9.4 PLANNING PERMIT APPLICATION PLP206/18 FOR DEVELOPMENT OF THE LAND FOR MULTIPLE DWELLINGS AT 8 EDEN PLACE WALLAN

File No: *PLP206/18*

8 Eden Place Wallan - Plans

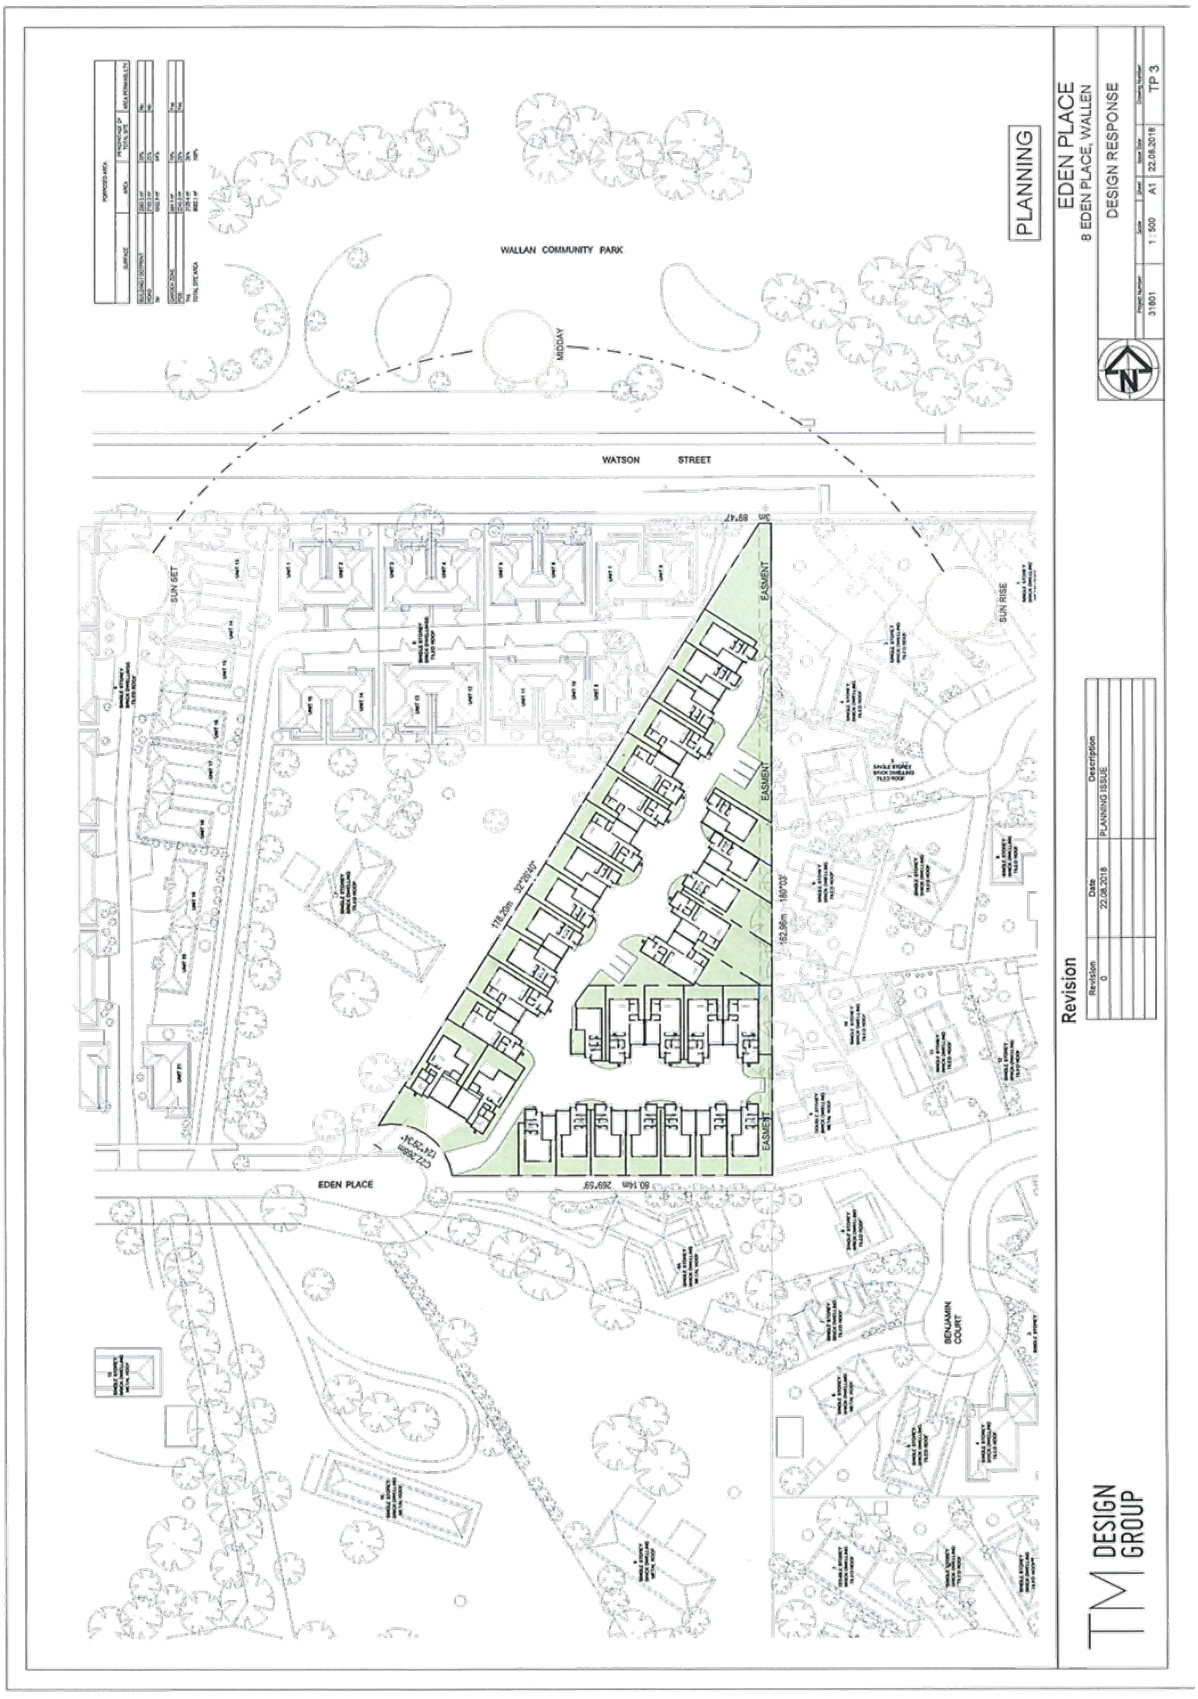
This is particularly evident through the proposal's use of common property and dead end driveways that do not allow for multiple ingress/egress points to the site. As the proposed development will continue the trend of isolated unit developments that Schedule 15 to the Development Plan Overlay sought to prevent, the proposal is considered to be inappropriate and does not meet the objectives of the Development Plan Overlay.

Loss of privacy as a result of the two-storey nature of the proposal.	The two-storey nature of the proposal is not considered to be inappropriate given that the proposal demonstrates sufficient setbacks from adjoining properties.
Limited access for emergency vehicles.	Given the dead-end nature of the common property access, the lack of vehicular connectivity to the wider area may impact the ability for emergency vehicles to access the site should there be congestion along Eden Place.

PLANNING
EDEN PLACE
8 EDEN PLACE, WALLEN
HOUSE TYPE 1
TP 7
Revision
TM DESIGN GROUP
TYPE 1 ROOF PLAN
TYPE 1 LEVEL 1 PLAN
TYPE 1 GROUND FLOOR
TYPE 1 - ELEVATION 4
TYPE 1 - ELEVATION 3
TYPE 1 - ELEVATION 2
TYPE 1 - ELEVATION 1
LIVING
DINING
KITCH
ENSUITE
BED 1
HALL
GARAGE

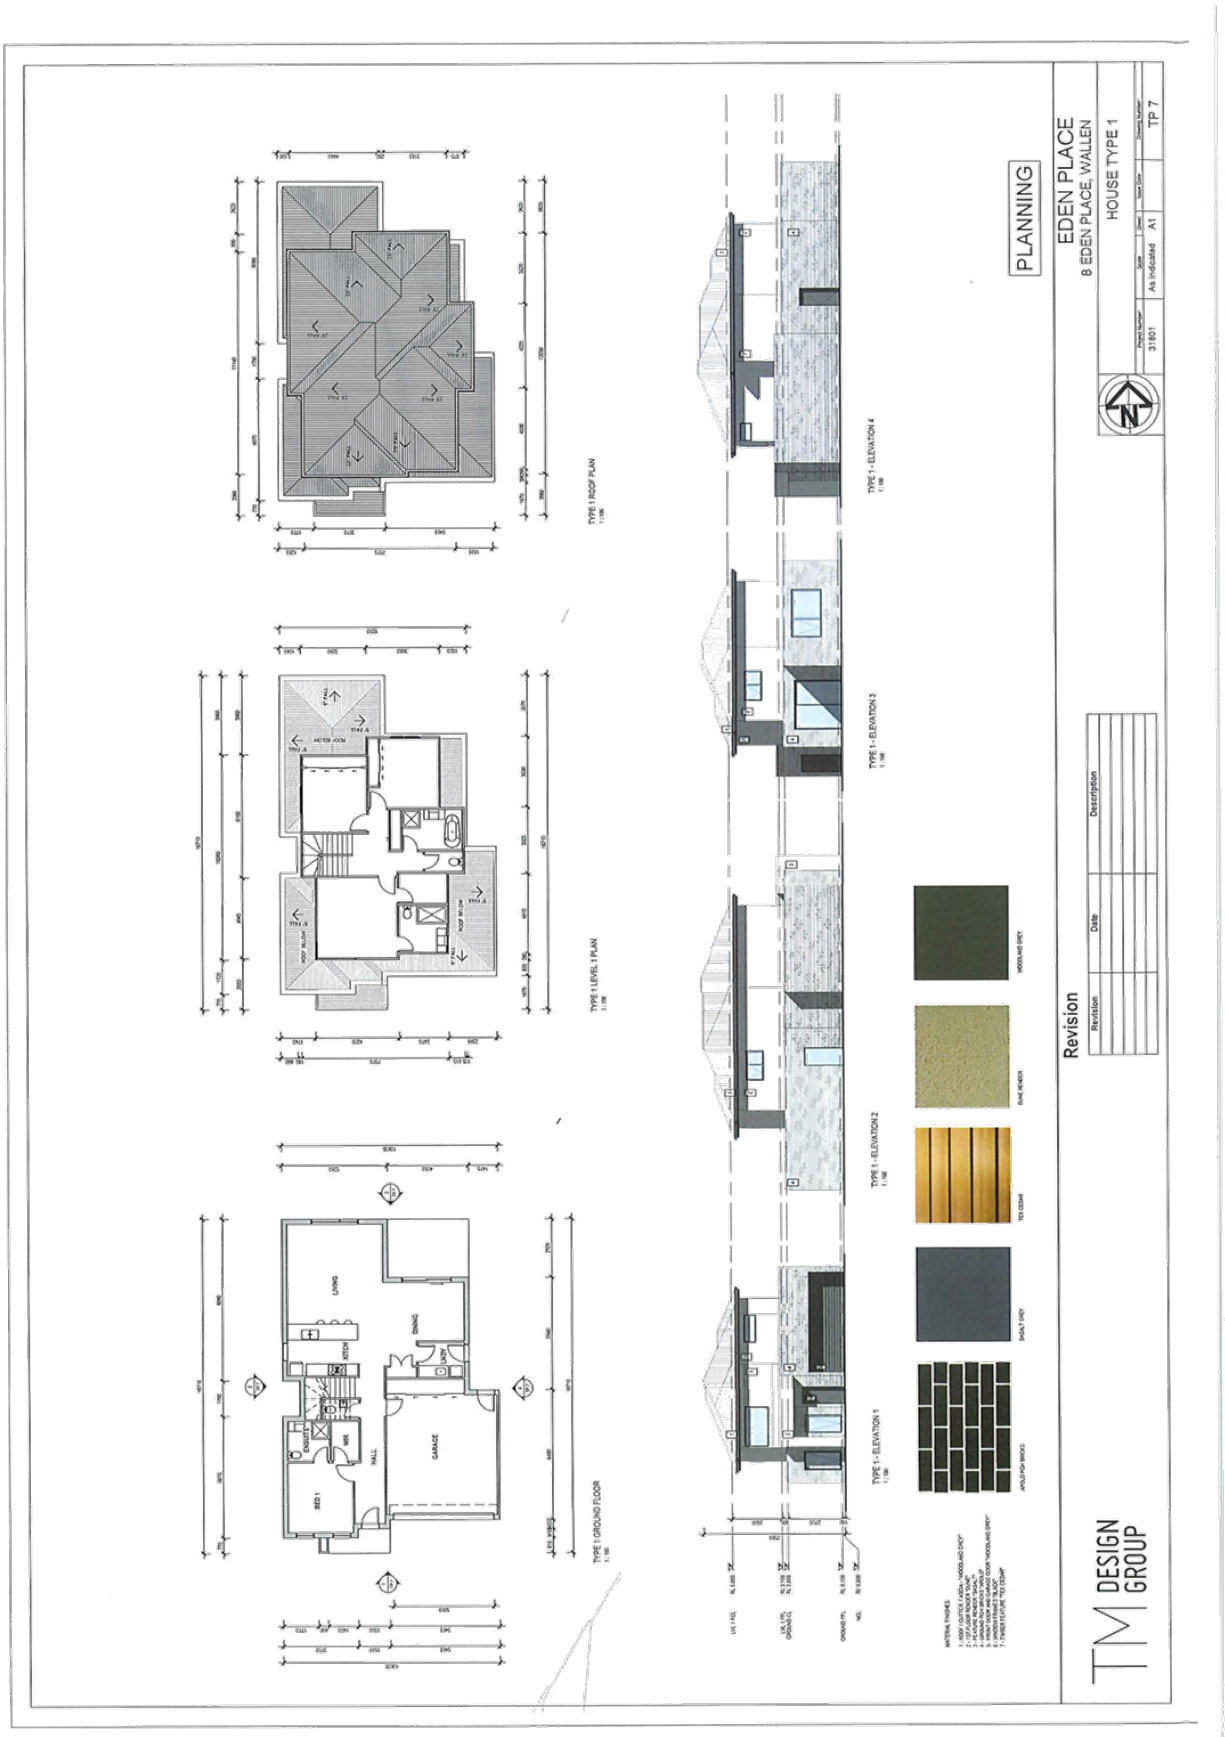
Dwelling type 1 contains open dining, kitchen and living area, bedroom 1, bathroom and garage within the ground floor and an additional three bedrooms and two bathrooms to the first floor. Notation on the floor plans for this dwelling indicate that the garage measures 5.4m in width (which is 100mm less than the double garage requirements).

Pursuant to the dimension requirements of Clause 52.06 for car parking spaces, the application does not provide appropriately dimensioned car parking spaces to allow for two car parking spaces to each three-or-more-bedroom dwelling proposed as part of the application. Pursuant to Clause 52.06-9, double car garages must be at least 6m in length and 5.5 metres in width (measures inside the garage or carport). The submitted plans only provide 5.4m in width, which is 100mm less than the standard

PLANNING
EDEN PLACE
8 EDEN PLACE, WALLEN
HOUSE TYPE 2
DANKOR ARCHITECTURE
Revision
Notes
TYPE 2 ROOF PLAN
TYPE 2 LEVEL 1 PLAN
TYPE 2 GROUND FLOOR
TYPE 2 - ELEVATION 1
TYPE 2 - ELEVATION 2
TYPE 2 - ELEVATION 3
TYPE 2 - ELEVATION 4

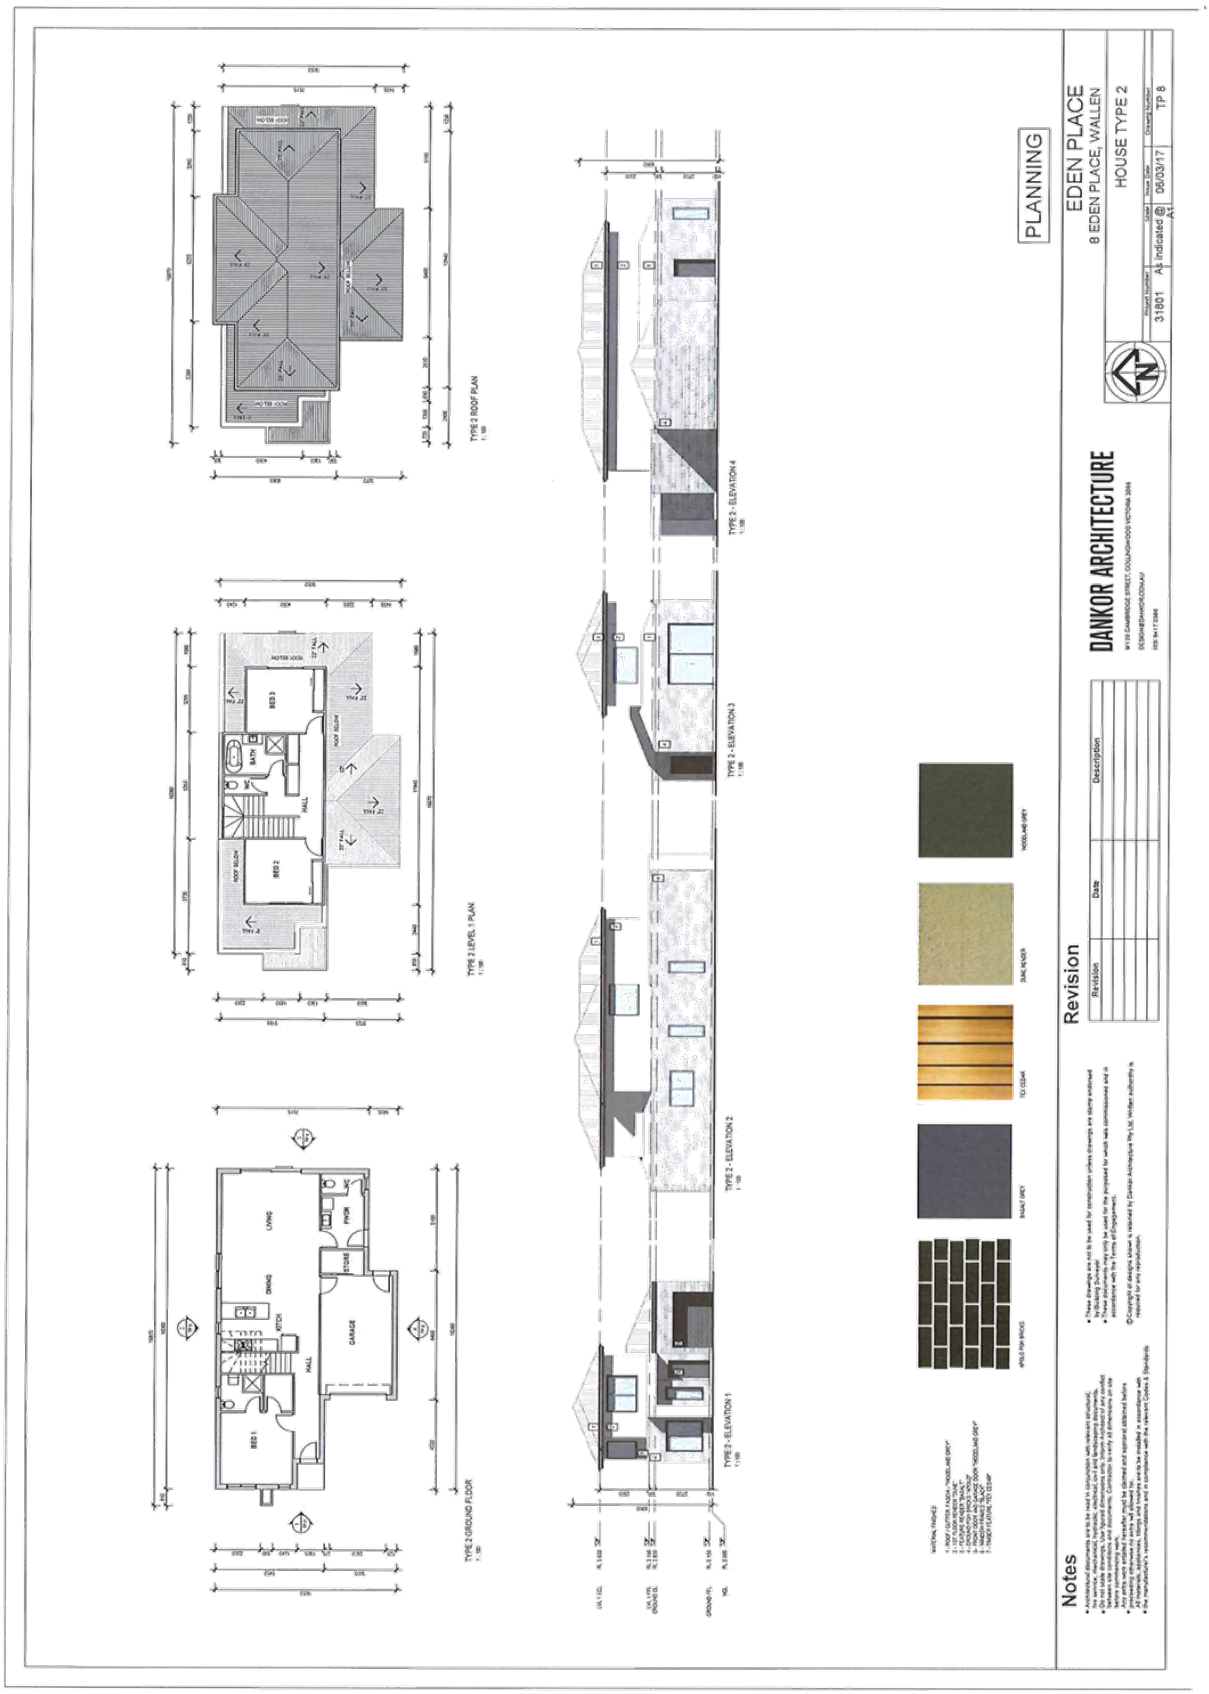
Dwelling type 2 is proposed to contain an open living, dining and kitchen area, garage, bedroom and two bathrooms to the ground floor, with the first floor to contain two additional bedrooms and another bathroom. The garage dimensions indicate that the garage is intended to accommodate a single car.

requirement. For three-bedroom dwellings that are proposed to contain a single car garage, the proposal does not meet the requirements for a tandem car parking space, as the space must be at least 4.9m in length with 500mm between the tandem space and the garage parking space. The proposal does not provide sufficient length to meet this requirement.

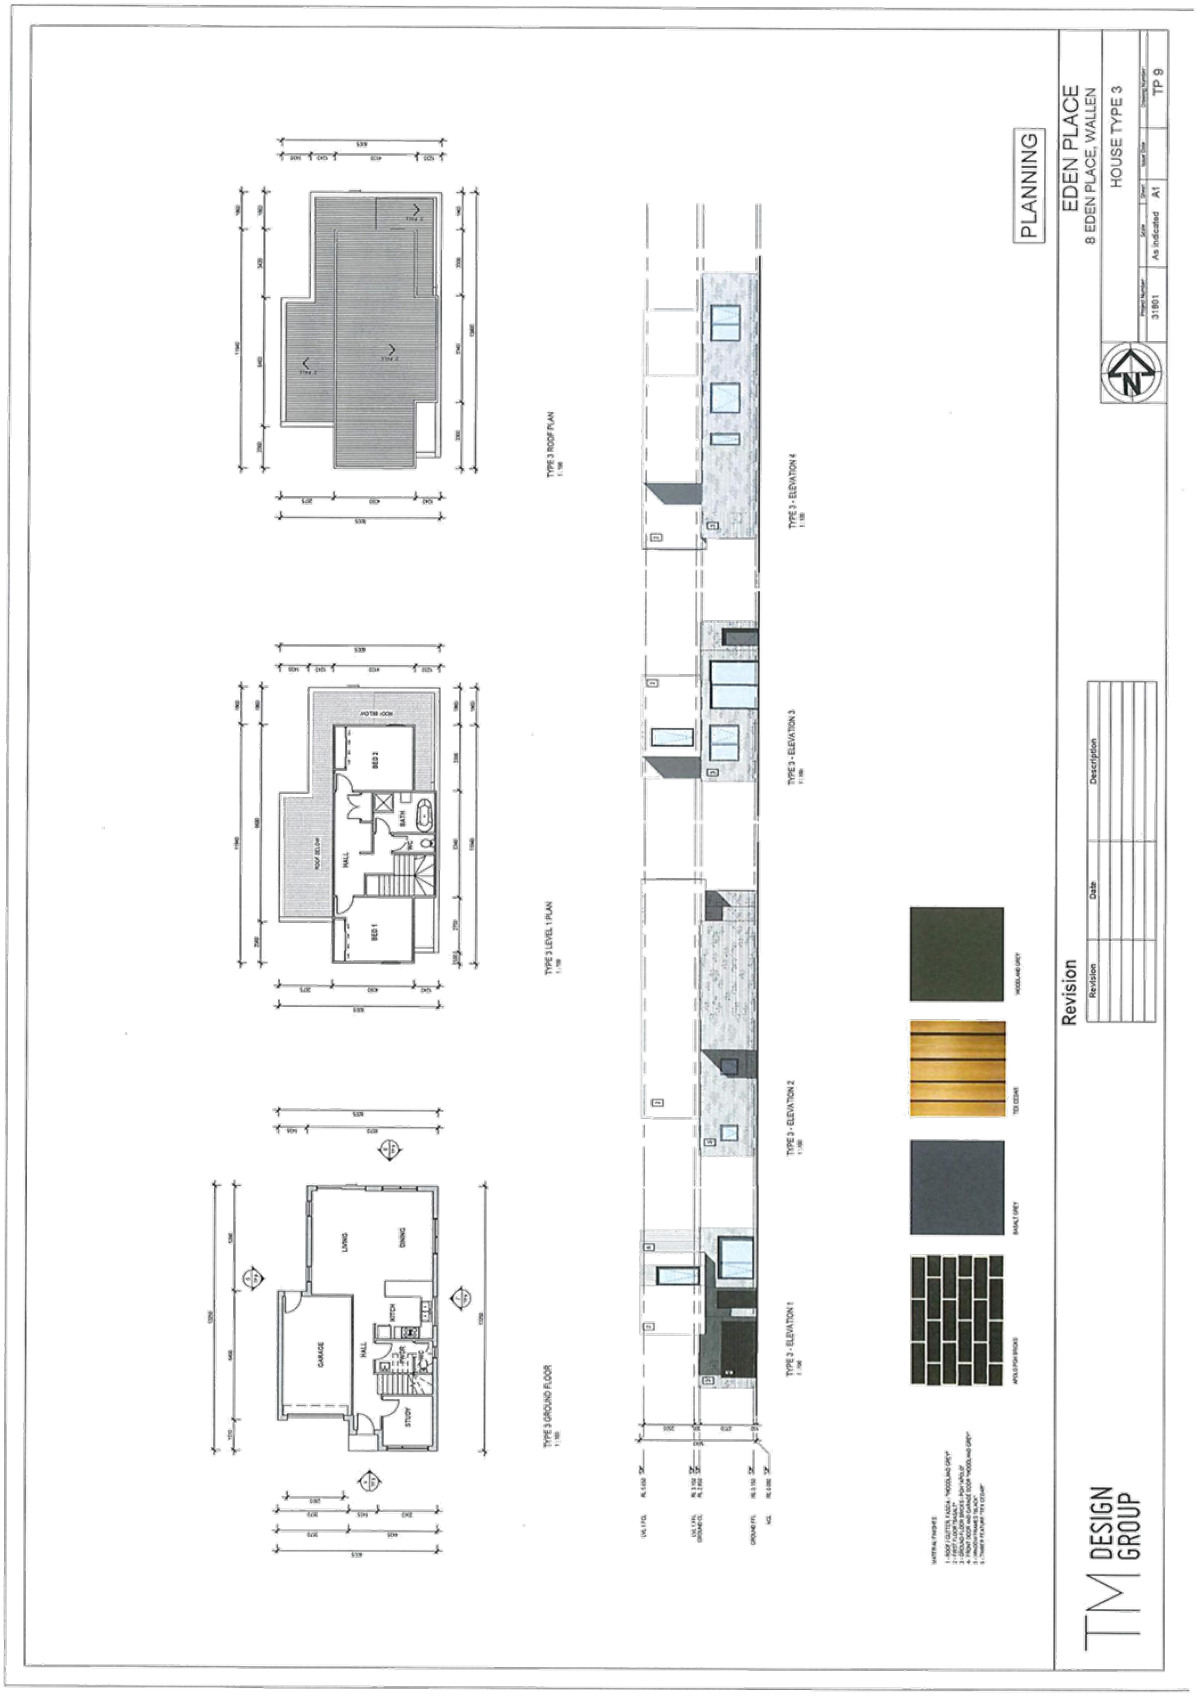
Dwelling type 3 is to contain an open living, dining and kitchen area with a bathroom, study and garage to the ground floor, with two bedrooms and a bathroom to the first floor. This dwelling type has a single car garage.
